Permit Hearing
Stillman Valley Ranchettes
Item #9

**NOTICE OF PERMIT HEARING OF THE
CLEARWATER UNDERGROUND WATER CONSERVATION DISTRICT**

**Stillman Valley Ranchettes
CUWCD Executive Summary**

Staff Report
Application for 2 Combination Drilling/Operating Permits
N2-20-008P, N2-20-009P

Figure 1. Theis curve match of the data collected from the observation well during the aquifer test.

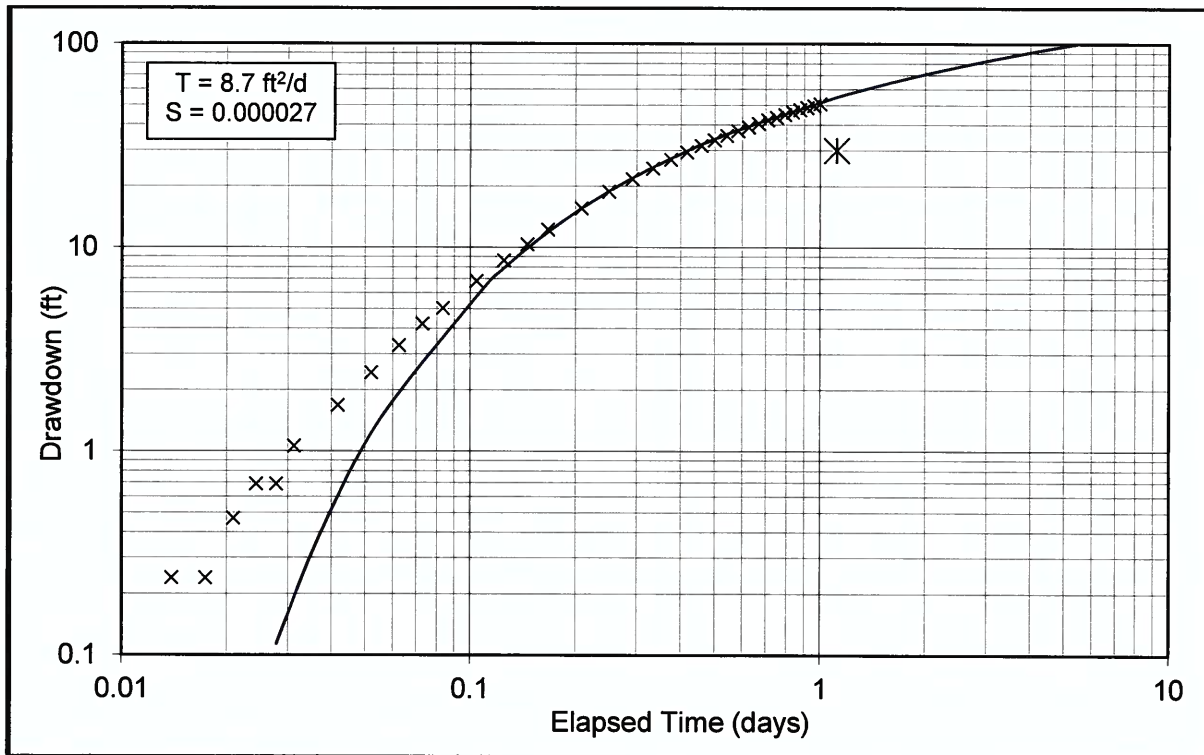
Directly using the Theis equation to match a theoretical curve with the observed water-level data to determine the transmissivity (T) and storage coefficient (S) is still applicable. Figure 1 illustrates our Theis curve match with the measured water-level data from the observation well. Based on our analysis the local transmissivity is slightly lower than reported and the storage coefficient is slightly higher than reported. However, the results from all of the analyses indicate the transmissivity and storage coefficient are low which will limit groundwater production. With the general agreement in low aquifer hydraulic property coefficients, for consistency with potential impact estimates provided by Worsley (2021b) we also used the aquifer hydraulic property coefficients he reported in our analyses and compared those results when necessary

with the estimated impacts using the values calculated using the Theis analysis (Figure 1).

Figure 2. Location of applicant's and nearby wells completed in the Lower Trinity Aquifer.

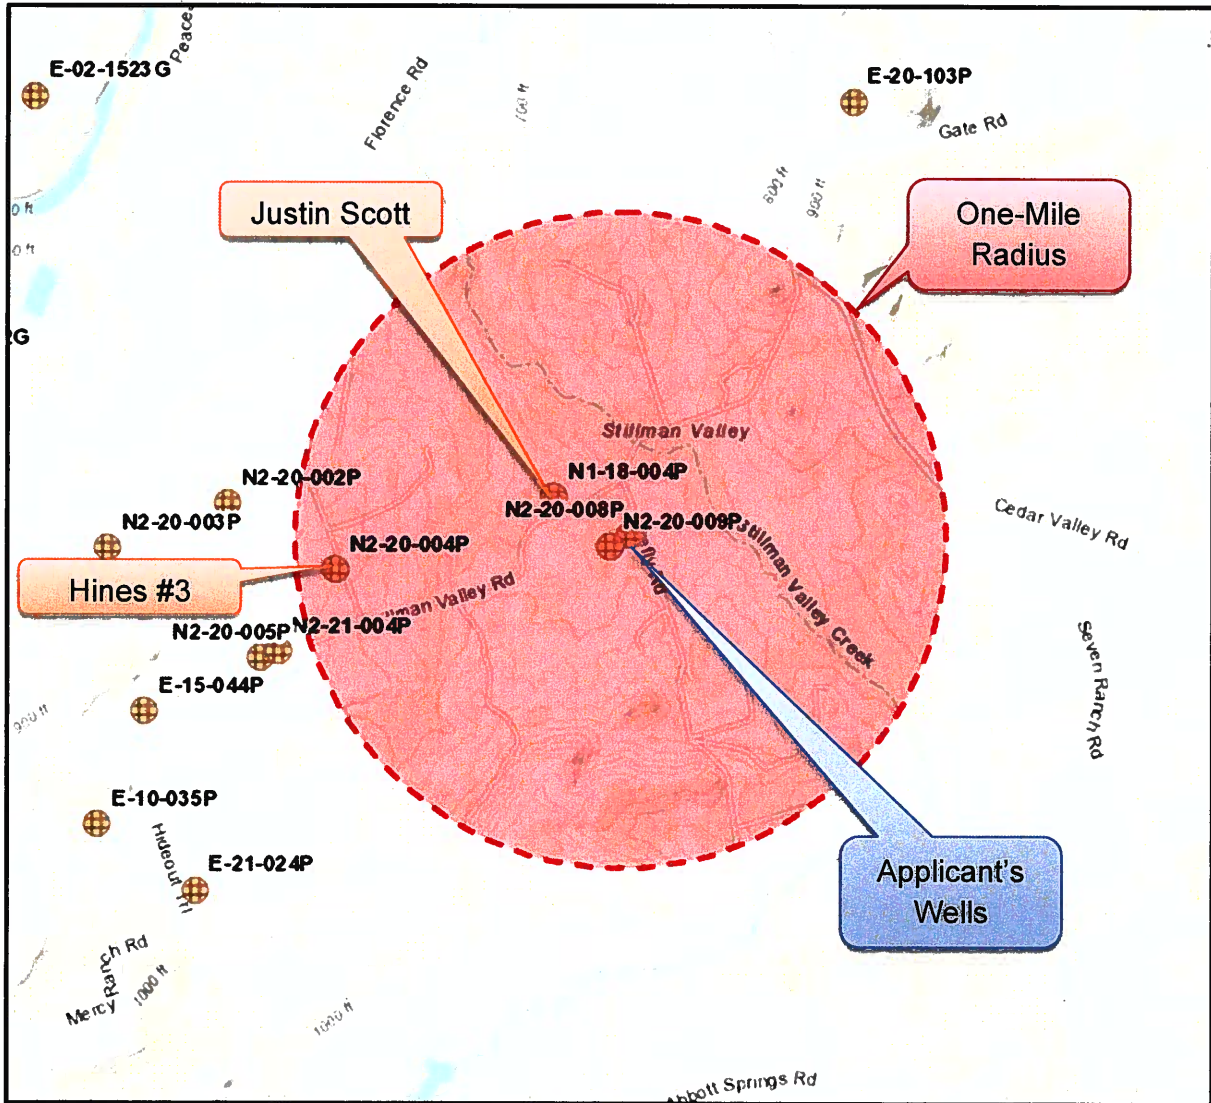
Currently there are two wells completed in the Lower Trinity Aquifer within one mile of the applicant's wells. Well N1-18-004P is 0.24 miles and well N2-20-004P is 0.87 miles away from the applicant's wells, respectively (see Figure 2). Table 1 presents the range in calculated drawdown, using the reported aquifer hydraulic property coefficients

(Worsley, 2021a), at the applicant's wells and other Lower Trinity wells within one mile of the applicant wells. For *1-Day Drawdown*, we applied the proposed instantaneous pumping rate for a period of 24 hours. For *30-Day Drawdown*, we assumed peak pumping during the summer of about 15 percent more than the average monthly amount (that is, the proposed annual production rate divided by 12 then multiplied by 1.15). For *1-Year Drawdown*, we used the proposed annual production amount.

Figure 3. Estimated depth to the formations at the applicant’s well location for Stillman Valley Ranchettes Well #1.

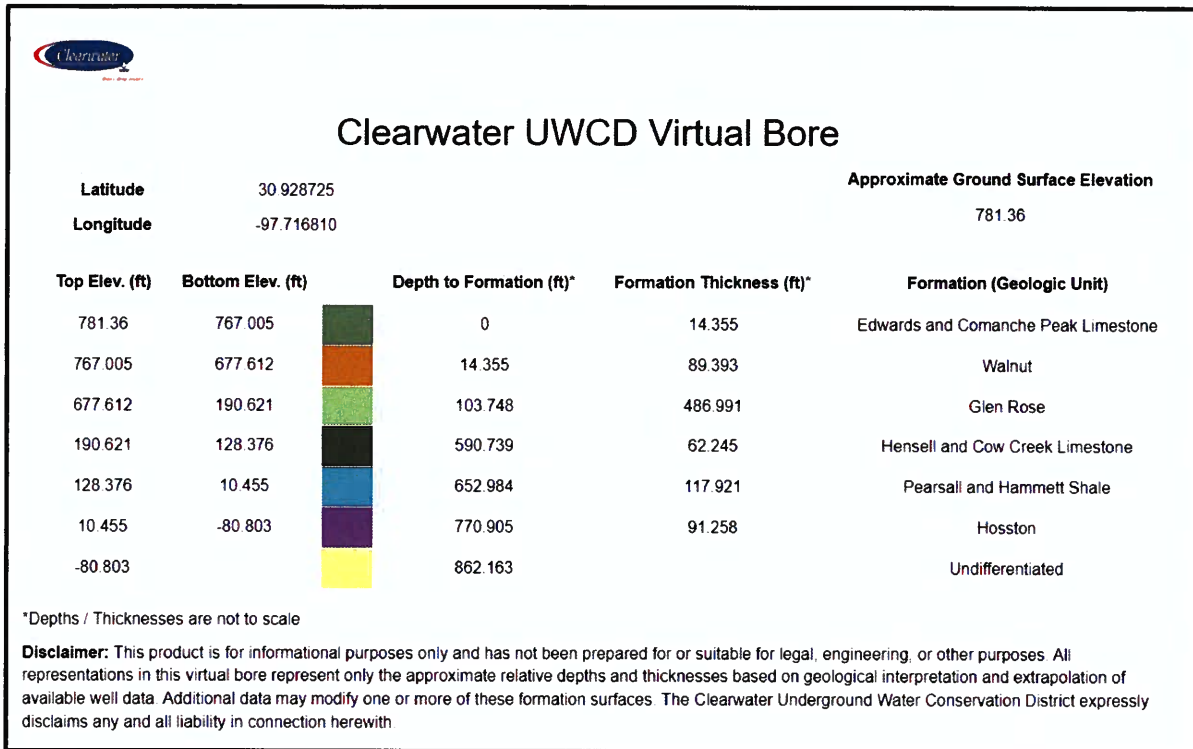
According the District’s virtual bore tool, the Lower Trinity Aquifer (that is, the Hosston Formation) is about 771 feet below ground level (BGL) and 91 feet thick at Well #1 (see Figure 3) and about 778 feet BGL and 124 feet thick at Well #2 (see Figure 4). According to Worsley (2021a), the Lower Trinity Aquifer (the Sligo/Hosston Formation) is about 676 feet BGL and 92 feet thick at Well #1 and about 676 feet BGL and 104 feet thick at Well #2. Review of the geophysical logs for the two wells suggests that the aquifer is shallower than the virtual bore suggests. The new data will be incorporated into future versions of the virtual bore.

With the shallower depth to the top of the formation, the available drawdown in the well is also reduced. Available drawdown is the height of water in the well above the point at which the anticipated production could no longer be maintained (that is, the minimum pumping water level). For the two wells, we calculated the available drawdown as the difference between the reported static water level and the top of the screen interval. While it is possible to draw the water down into the screen interval, the ability to maintain production may be diminished when this occurs.

Figure 4. Estimated depth to the formations at the applicant’s well location for Stillman Valley Ranchettes Well #2.

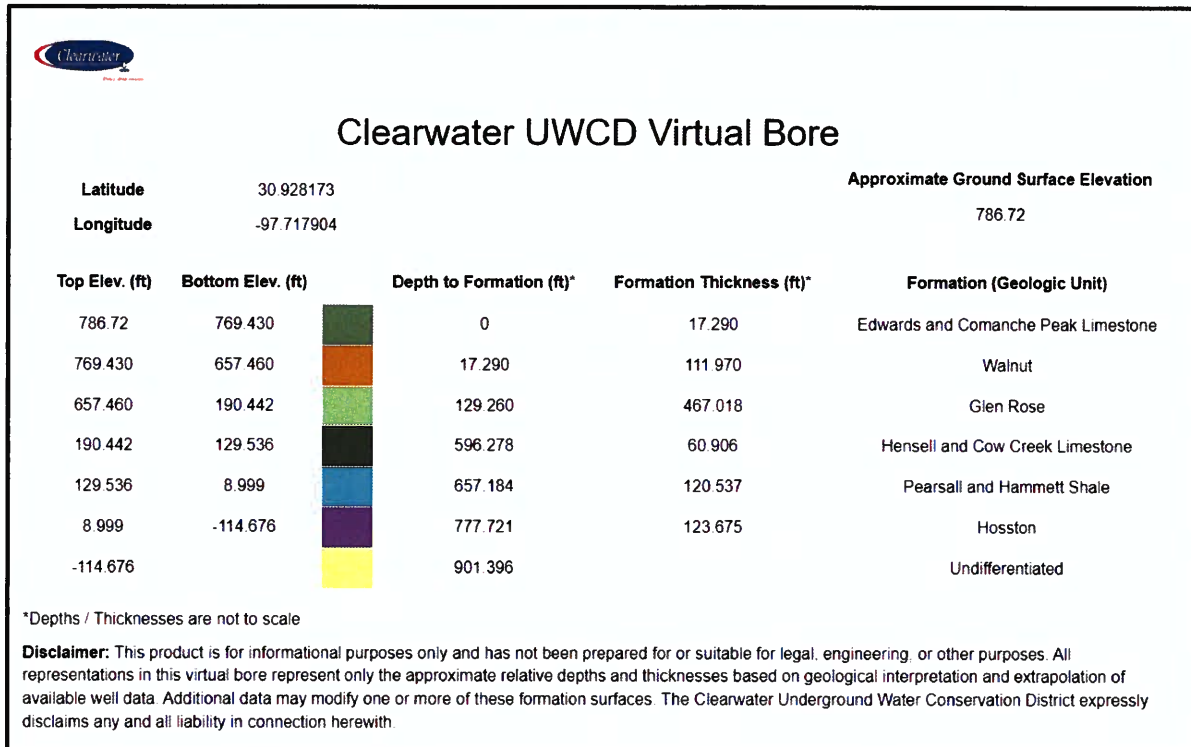
Adding the 1-year predicted drawdown and the drawdown that occurs each time the well starts pumping at the instantaneous rate (that is, instantaneous drawdown), we can estimate the pumping water level in the well after one year of operation. Incorporating the observed regional water level trend, we can then estimate how many years before the water level reaches the minimum pumping water level after which time production capacity may diminish. That is, we are able to estimate the years of available groundwater for the proposed development.
